Amendments to the Drawings:

ANNOTATED SHEET
TO SHOW
CHANGES MADE

Figure 4

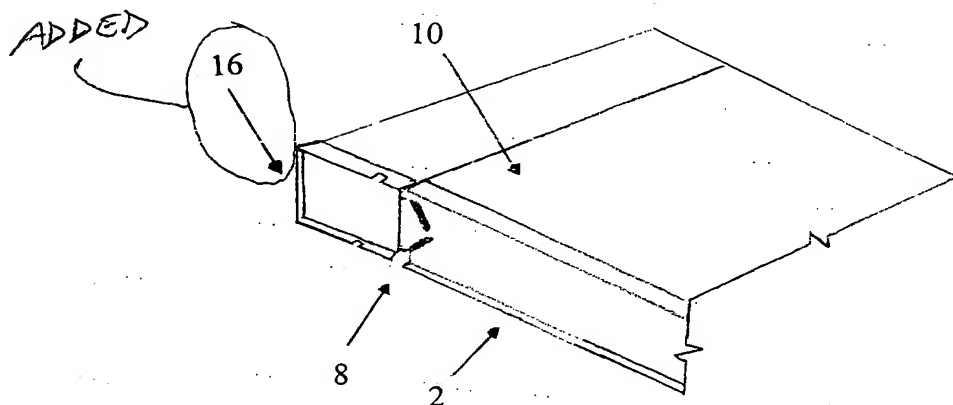
The drawing sheet attached in connection with the above-identified application containing Figures 4 and 5 is being presented as a new formal drawing sheet to be substituted for the previously submitted drawing sheet. Figure 4 has been amended. Appended to this amendment are annotated copies of the previous drawing sheet which has been marked to show changes presented in the replacement sheet of the drawings.

The specific changes which have been made to Figure 4 is to add item "16" to the figure.

For better clarity, claim 1 now recites a header tank, as conventionally forms part of a heat exchanger, e.g., a condenser or radiator, as disclosed in the application. Fig. 4 has been amended to generally identify a header tank 16. The alternative subject matter of previous claim 2 has been split between amended claim 2 and new claims 17-19. Other preferred aspects of the invention are claimed in new claims 13-16.
